ADDENDUM NO. 1
TO: PROJECT MANUAL
FOR:

ARKANSAS TECH UNIVERSITY (ATU) | TUCKER COLISEUM
PHASE 1 MECHANICAL ROOM RENOVATION (HW)
BID NO. B025054

18 October 2025

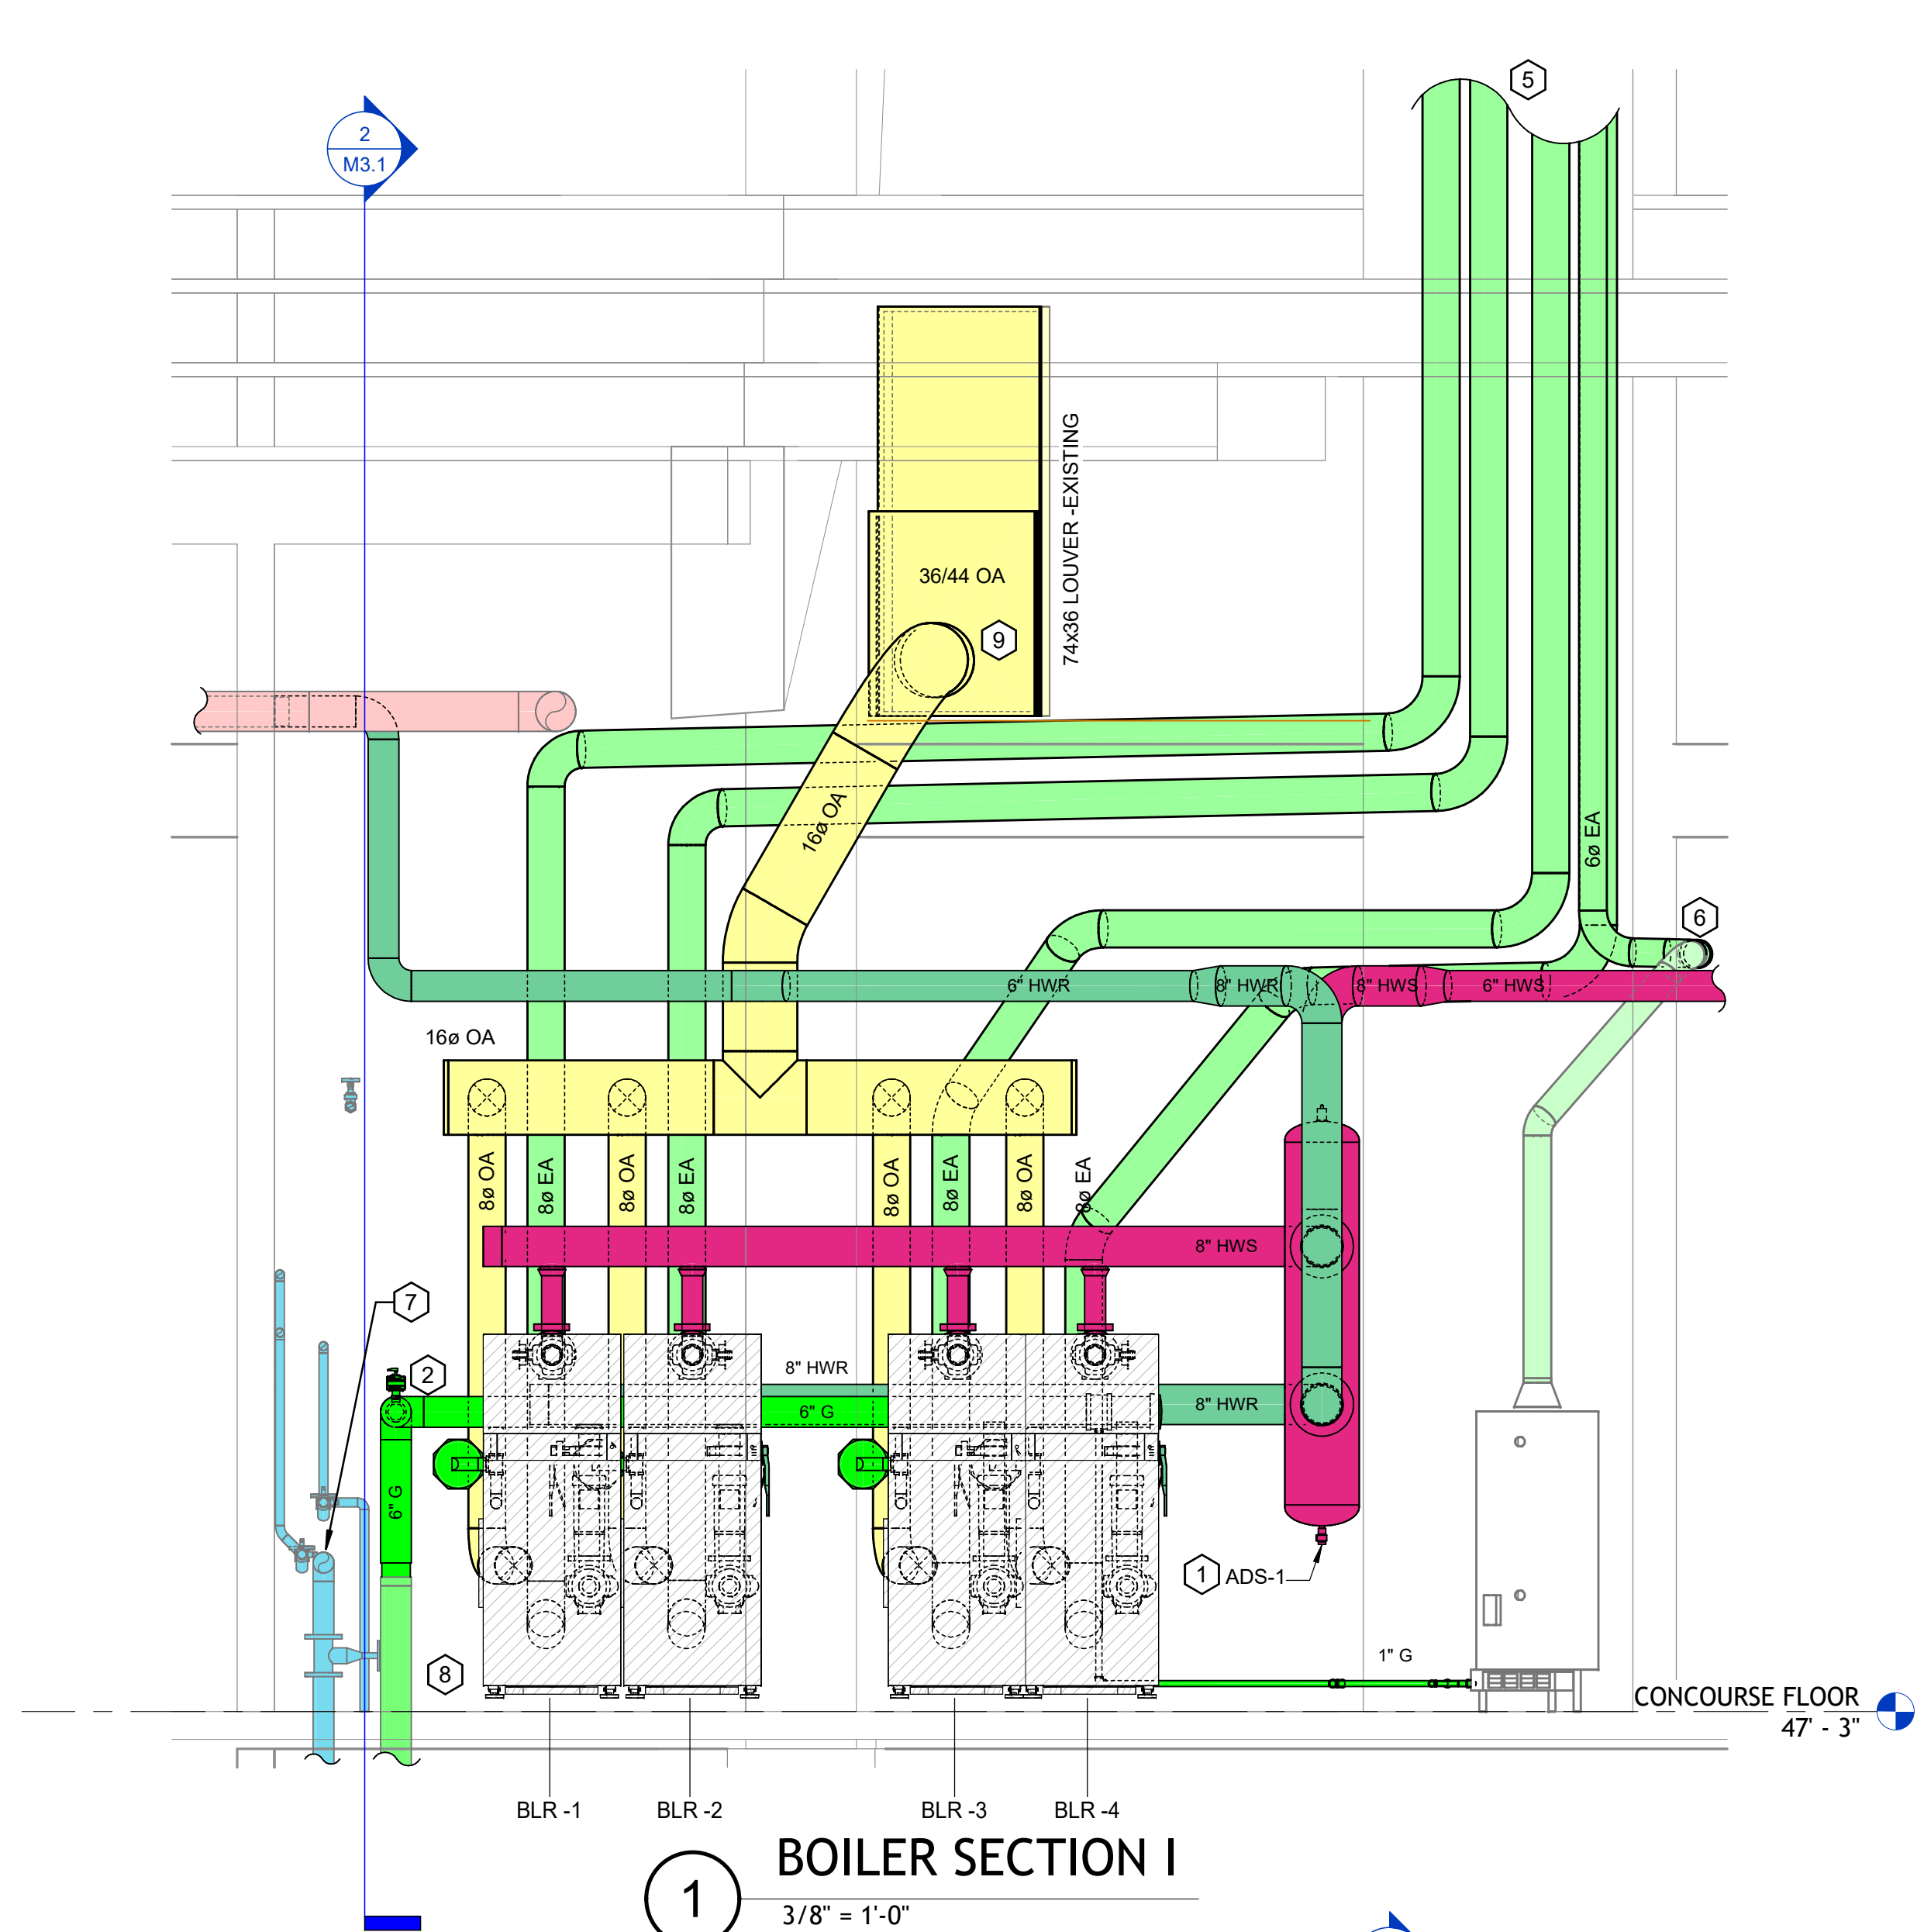
1. Division 00, Section 00100 – INFORMATION FOR BIDDERS: 12 SUBMISSION OF BIDS, Item 12.1: omit the reference to bound bids in the project manual as shown below:

Bids shall be submitted at the time and place indicated in the Advertisement or Invitation to Bid. Bids shall be ~~bound in the original project manual and shall~~ be enclosed in an opaque sealed envelope, marked with the Project Title (and, if applicable, the designated position of the Project for which the Bid is submitted) and name, address, and contractor's license number of the Bidder, and accompanied by the Bid security and other required documents. If the Bid is sent through the mail or other delivery system, the sealed envelope shall be enclosed in a separate envelope with the notation "BID ENCLOSED" on the face of it.
